Report: TAB Report
Function: Test, Adjust, & Balance
Date: 01/20/2026
Completed By: National TAB

03-16-26 WAWA #7222 SILVERTON, OH

Project: 03-16-26 WAWA #7222 SILVERTON, OH

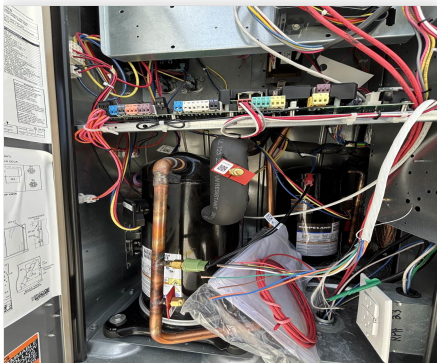
Issue Name : EF-1 face dampers not installed
Description : The restroom exhaust diffusers are supposed to have face dampers installed for balancing but they are missing. This will prevent the completion of correctly balancing the diffusers.
Created By : National TAB **Assigned To :** National TAB - Will Turnbough
Status : Open
Priority : High **Asset Tag :**
Originated Date : 03/18/2026 - Corey Dick - National TAB

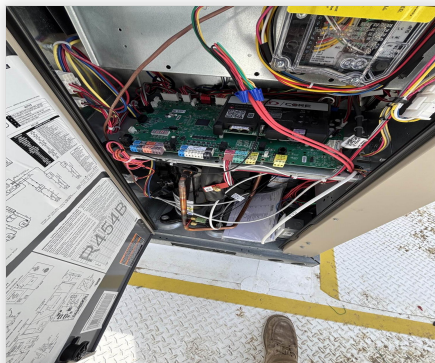
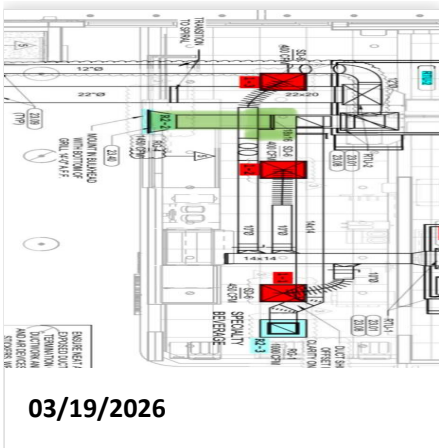
Issue Name : RTU temp sensor wiring not landed
Description : The wiring for the temp sensors is not landed at any of the RTU's. The unit has no temp being relayed to it and this makes it so that no cooling or heating will be called for.
Created By : National TAB **Assigned To :** National TAB - Will Turnbough
Status : Open
Priority : Urgent **Asset Tag :**
Originated Date : 03/19/2026 - Corey Dick - National TAB
